Diversified Metal Fabricators Service Bulletin SB 2079

Title	RW-1019B Front Pin Lock Washer Replacement
Document No.	SB2079 Rev #
Issue Date	11/11/2019 (TAM)
Release	General
Units Affected	RW-1019B models (front only) with ship dates prior to 11/8/19 (~SN 45680)
Purpose	Reduced potential for front pin separation

Figure 1. RW-1019B Front Pin Lock Washer Replacement – Ford & Ram

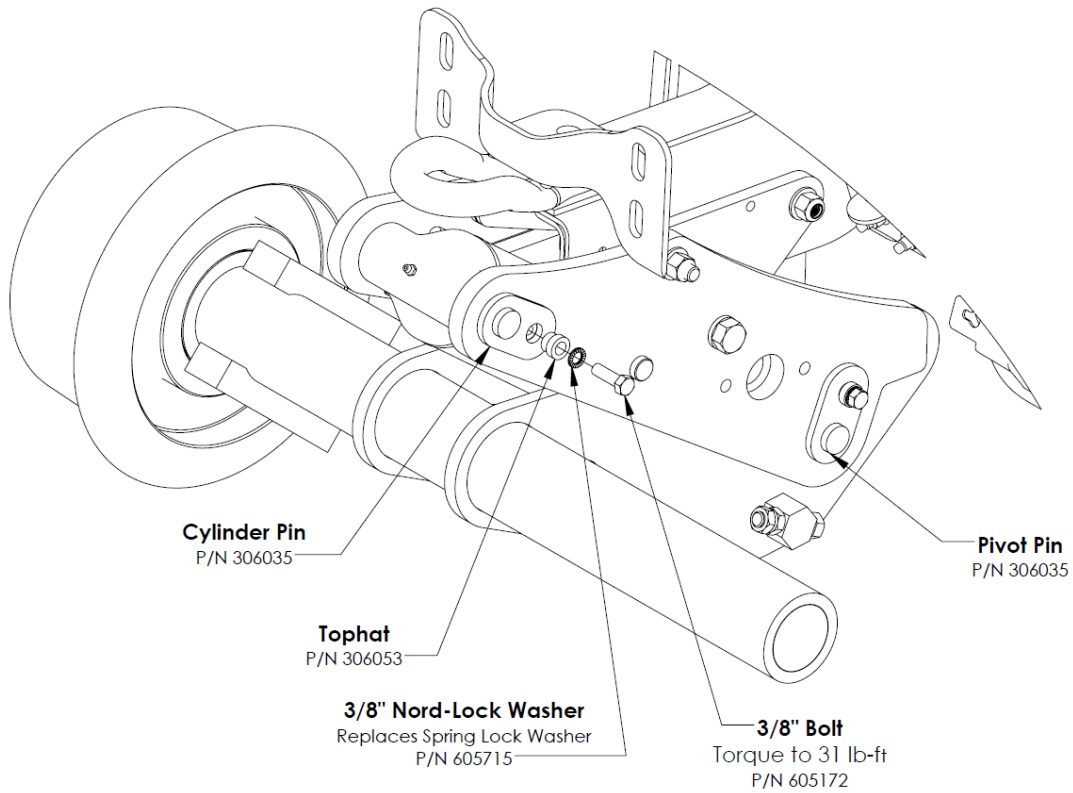
Under sustained vibration, the bolts retaining some pins in front RW-1019B assemblies may loosen and fall out over time. This could allow the pins to back out, causing key railgear components to separate. While DMF is unaware of any reported failures of this type occurring in the field, customers are urged to inspect these pins and replace the lock washers as a preventative measure. Replacing the standard spring lock washers under the retaining bolt with upgraded Nord-Lock washers provided by DMF will greatly increase the vibration resistance of the retaining bolt.

1. Contact DMF and request QUANTITY 4 of P/N 605715 (NORD-LOCK WASHER, 3/8").
2. Remove the 3/8" bolts retaining the cylinder pin and the pivot pin (**FIGURE 1**; Ford shown, Ram similar).
3. Remove and discard the 3/8" spring lock washers.
4. Make sure the "top hats" are reinstalled against the pin head.
5. Reinstall 3/8" bolts using 3/8" Nord-Lock washers. Nord-Lock washers are a two-piece design, but are held together with adhesive for ease of assembly. Do not separate the washer pairs.
6. Torque 3/8" bolts to 31 ft-lb.
7. Repeat procedure on remaining pins on opposite side of the vehicle.
8. The shorter pin through the rod end of the cylinder is secured with a nylock nut and does not require a Nord-Lock washer.
